January 19, 2007

Husky's Response to EnCana's Information Requests for Husky January 12, 2007

A) With respect to the Husky's Model Study Report dated January 8, 2007 please:

Pressure vs Time

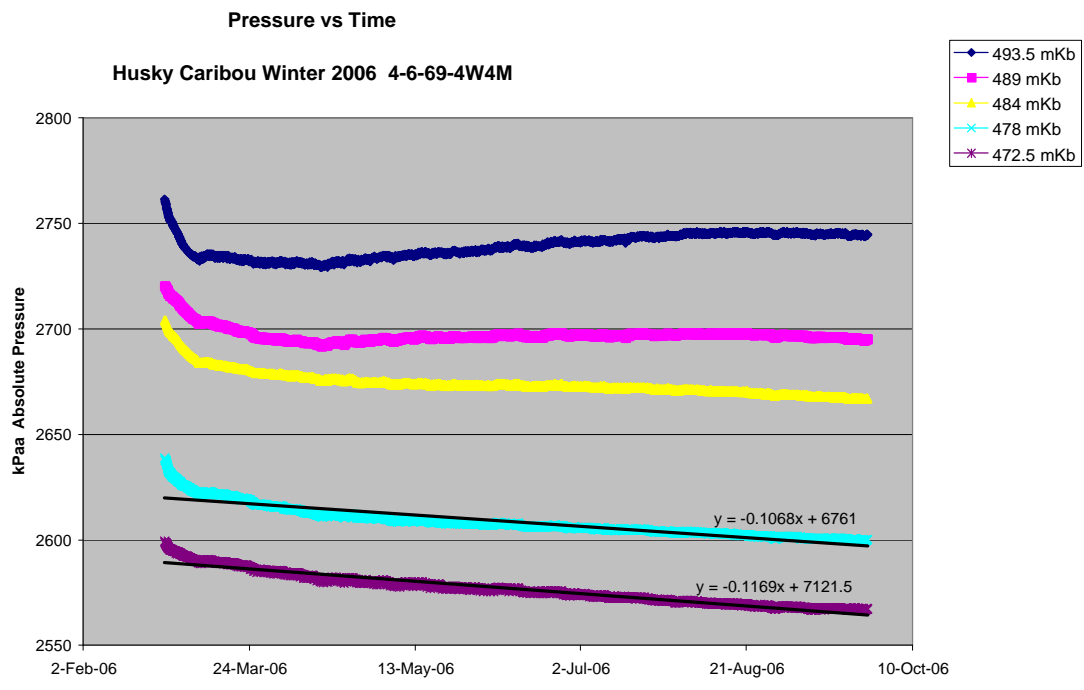
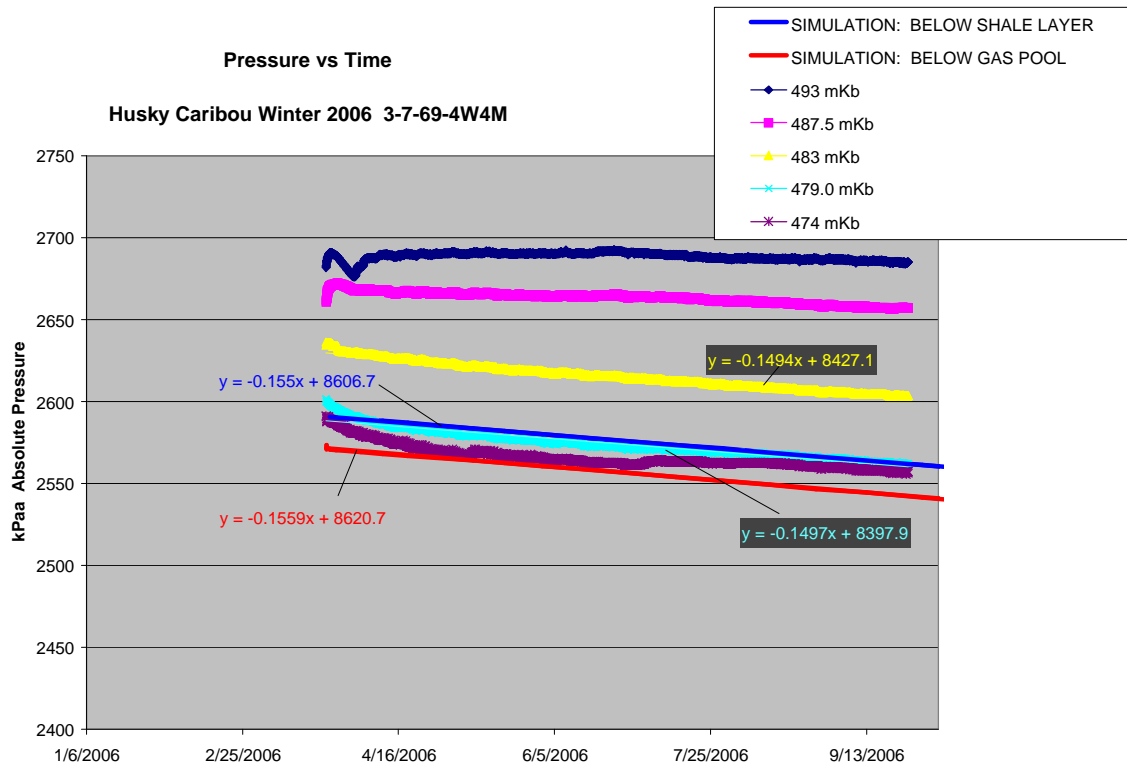
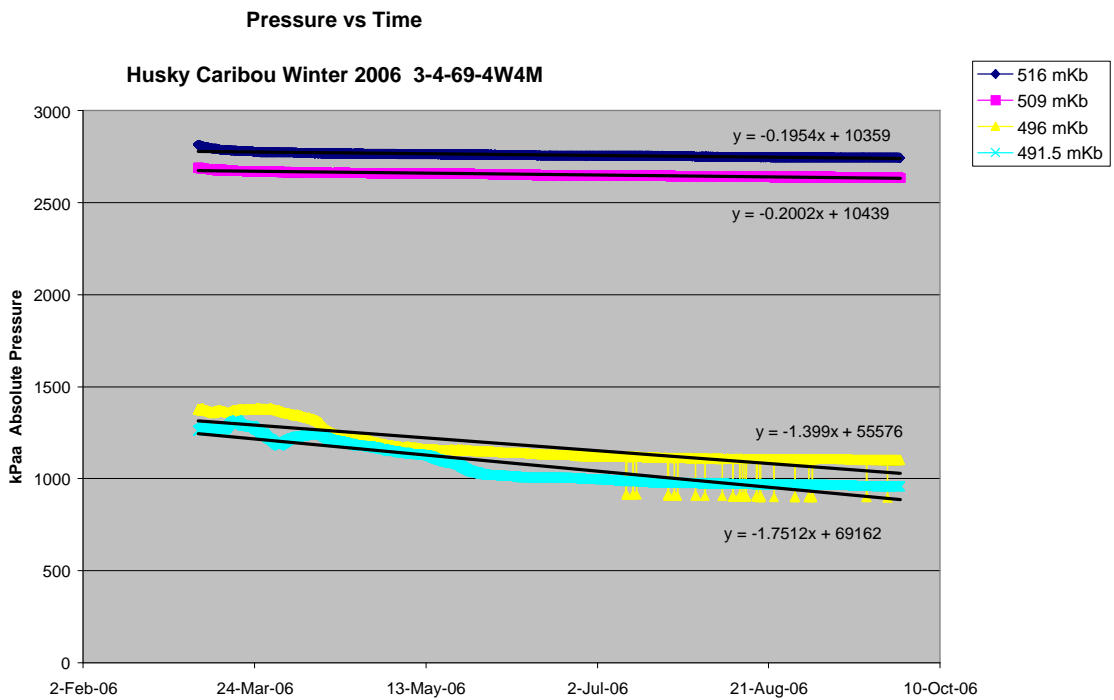
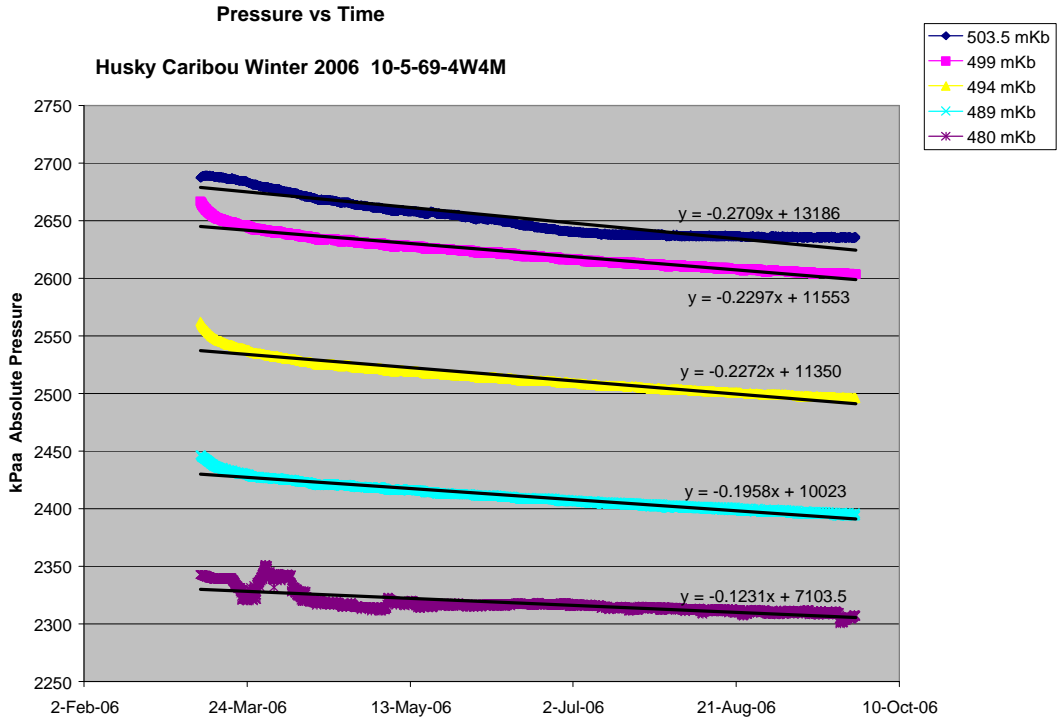
8. Provide details on the comments on page 8 that "the depletion rates lead to pressure production over periods of time reasonably consistent with measured piezometer data" and on page 18 in item 3a "The pressure depletion observed in the field can also be duplicated in the simulation model". Please include the point in time at which pressure matches were observed, the piezometer pressures used, and how the model gas cap pressures at the time of the match relate to current estimated pressures in the Fisher Clearwater B pool. Why, after going to all the expense and effort to gather piezometer data, did Husky choose to model an area that includes only one piezometer well?

The piezometer data was necessary to prove conclusively that the bitumen zone pressures are being lowered by the depletion of gas caps in the area. This objective has been achieved. It has to be kept in mind that the selected model area had to contain enough wells to describe the geology sufficiently and yet had to be small enough so that the number of grid blocks would not become intractable.

The pressure decline rate from the piezometer data was reasonably well matched by the reservoir simulation model. These matches are shown in the attached plots. It is noted that the pressure decline rate observed in the reservoir simulation model is consistent with that of the field data (simulation values have been shifted in time to line up with first data point of piezometer data). The first plot shows the pressure decline rate from simulator together with straight line fits to the observed pressure data so that rate of pressure decline can be compared. Observed pressure decline rates are also shown on all the other plots as well. A comparison with pressure decline rate from all wells shows that the pressure decline rate of the simulations is comparable to that of the field data and is in fact conservative with respect to the well (16-7) in the area of interest.

A very important point to make is that no unusual modifications to the geology were used (such as non-geologically based reduced permeability barriers or transmissibility factors) to achieve the pressure history match.
